HISTORIC AND DESIGN REVIEW COMMISSION

November 15, 2017

HDRC CASE NO: 2017-549
ADDRESS: 305 LAMAR ST
LEGAL DESCRIPTION: NCB 519 BLK 24 LOT 12
ZONING: R-5 H
CITY COUNCIL DIST.: 2
DISTRICT: Dignowity Hill Historic District
APPLICANT: Michelle McKenna
OWNER: Michelle McKenna
TYPE OF WORK: Window replacement, exterior modifications
APPLICATION RECEIVED: October 27, 2017
60-DAY REVIEW: December 26, 2017

2 NEW FRONT ELEVATION
SCALE: 3/16" = 1'-0"

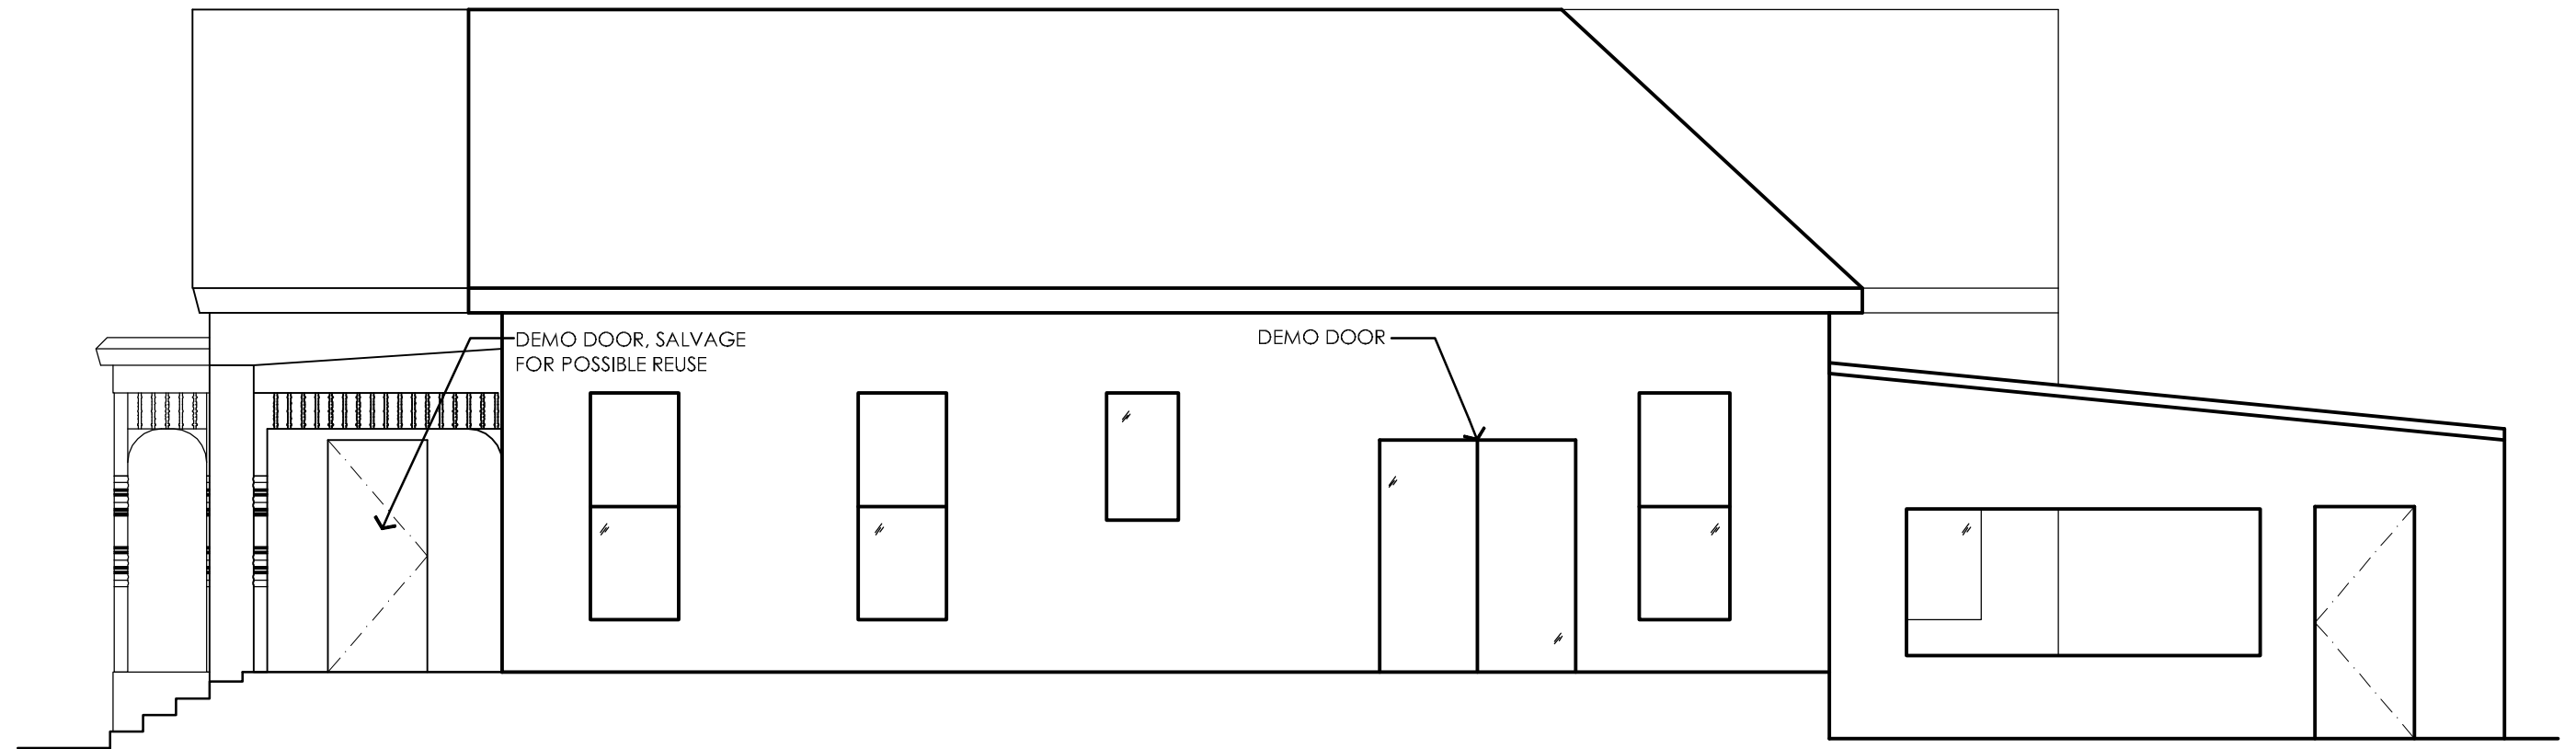
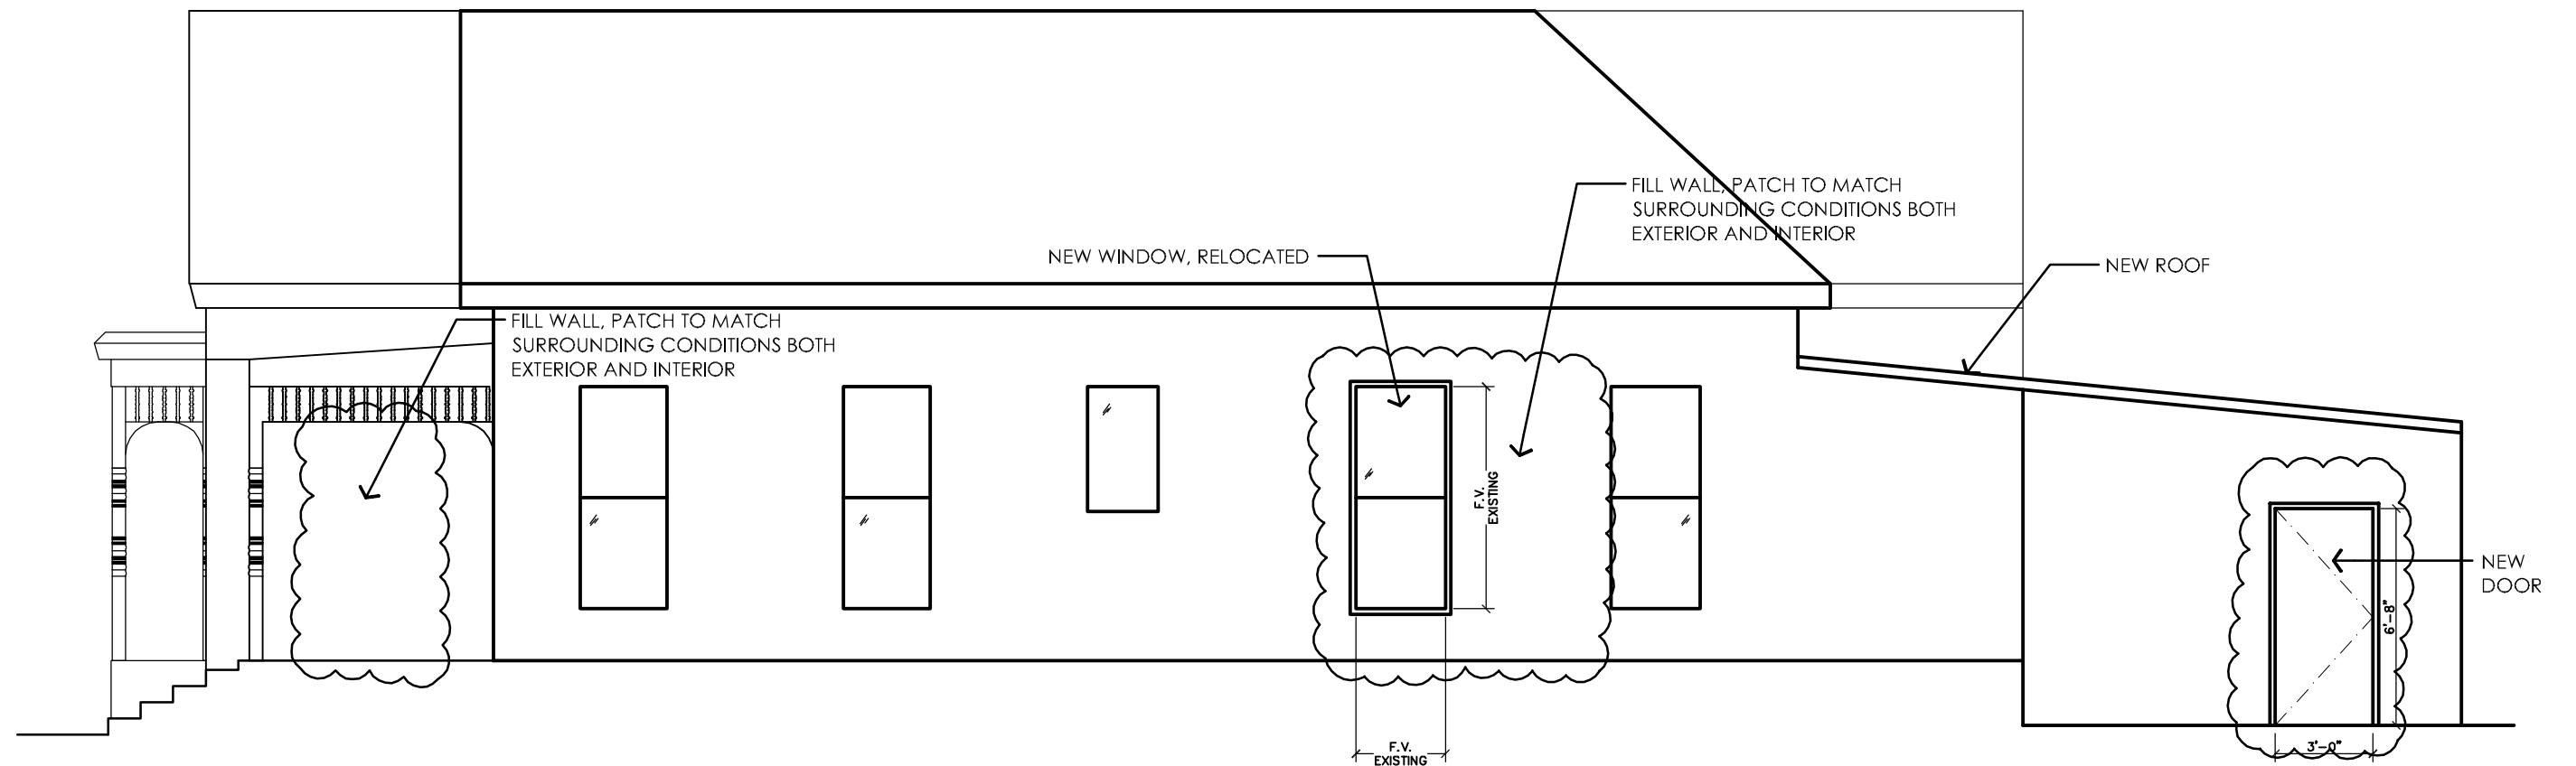
- b. **WOOD WINDOW REPLACEMENT** – The applicant is requesting approval to replace three existing one over one wood windows with one over one vinyl windows with faux divided lites. The applicant has stated that the windows will match the size of the existing openings. According to the Historic Design Guidelines, new windows should match the historic or existing windows in terms of size, type, configuration, material, form, appearance, and detail when original windows are deteriorated beyond repair. The existing wood windows are one of the few that remain in a structure that has been heavily modified over the years. Staff does not find the use of vinyl windows appropriate as replacement for wood windows.

- c. **ALUMINUM WINDOW REPLACEMENT** – The applicant is requesting approval to replace four non-original aluminum windows with one over one vinyl windows with faux divided lites. The existing aluminum windows are not appropriate for the style of the home in terms of profile, inset, and dimensions. According to the Historic Design Guidelines, non-historic incompatible windows should be replaced with windows that are typical of the architectural style of the building. Staff finds that vinyl windows may be appropriate for replacing incompatible aluminum windows if the windows meet all the required specifications listed in the recommendation.

Item 1, Staff does not recommend approval of the replacement of the existing wood windows with vinyl windows based on finding b. Staff recommends that the windows be restored in place. If the windows are deteriorated beyond repair, the applicant should furnish evidence to that effect to staff. Staff recommends that windows deteriorated beyond repair be replaced with one over one wood windows. Final window manufacturer specifications must be submitted to staff for review and approval. Meeting rails must be no taller than 1.25” and stiles no wider than 2.25”. There should be a minimum of two inches in depth between the front face of the window trim and the front face of the top window sash. This must be accomplished by recessing the window sufficiently within the opening. Window trim must feature traditional dimensions and architecturally appropriate sill detail. Window track components must be painted to match the window trim or concealed by a wood window screen set within the opening.

Item 2, Staff recommends approval of the replacement of non-original aluminum windows with vinyl windows based on finding c with the following stipulations:

- i. That the windows be one over one configuration and do not feature faux divided lites.
- ii. That final window manufacturer specifications must be submitted to staff for review and approval and meet the following stipulations: that meeting rails be no taller than 1.25” and stiles no wider than 2.25”. There should be a minimum of two inches in depth between the front face of the window trim and the front face of the top window sash. This must be

accomplished by recessing the window sufficiently within the opening. Window trim must feature traditional dimensions and architecturally appropriate sill detail. Window track components must be painted to match the window trim or concealed by a wood window screen set within the opening.
